MAS Intimates Bangladesh (Pvt.) Ltd.(Unit-03)

Observations

Discrepancies in as-built drawings

Mismatch found in column schedule & scan report

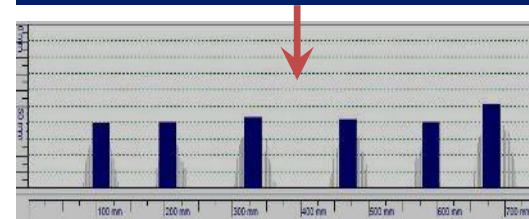
Number of re-bar in C-1 & C-2 columns have been found less than the number mentioned in column schedule above 2nd floor.

Number of re-bar in circular column has also been found less than the number mentioned in column schedule above 2nd floor.

Observations : Discrepancies in as-built drawings

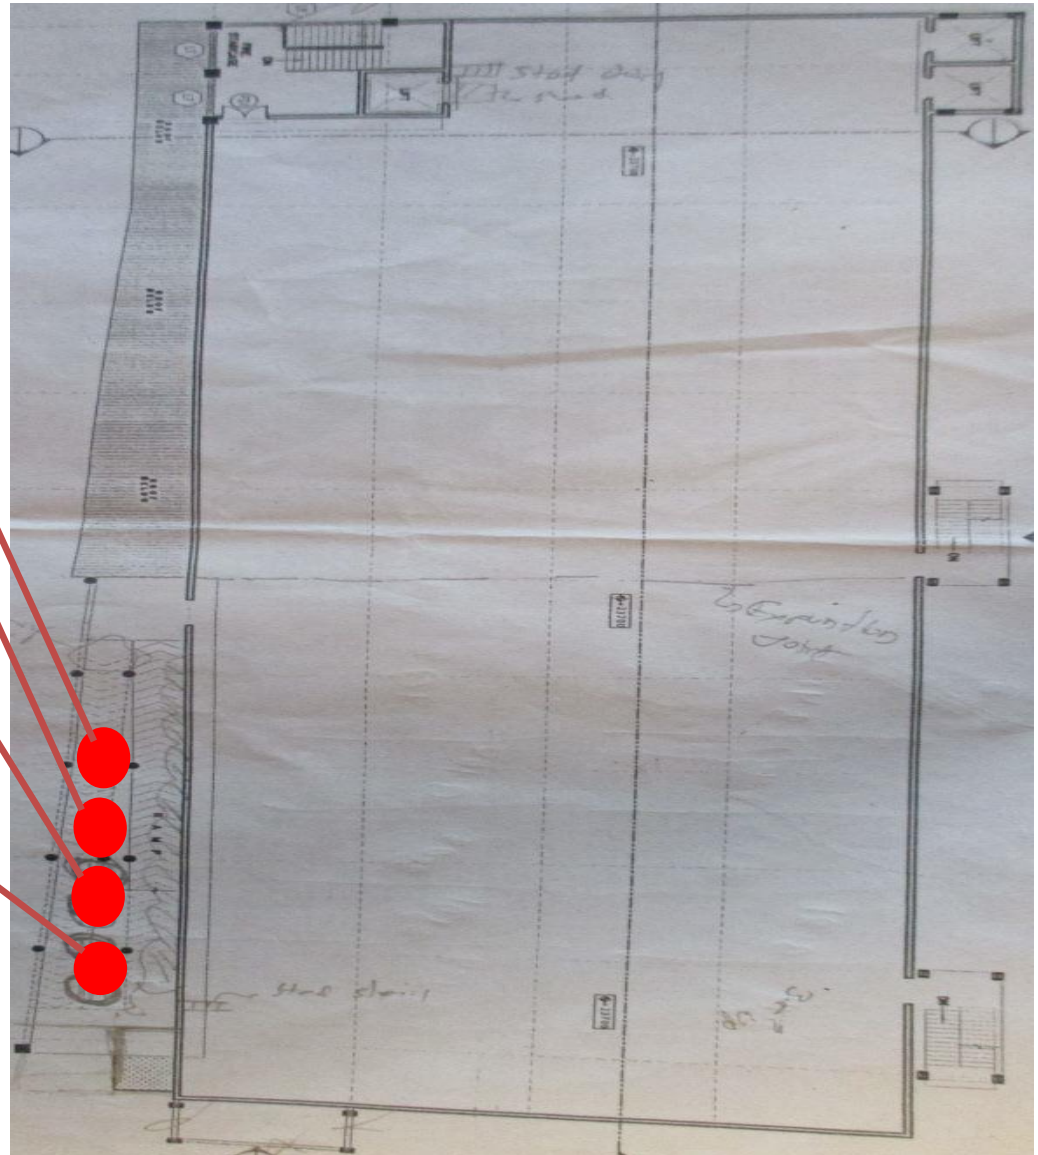
4 Number plastic water tanks on the roof top of Ramp of capacity 5000L which are not mentioned on roof top plan.
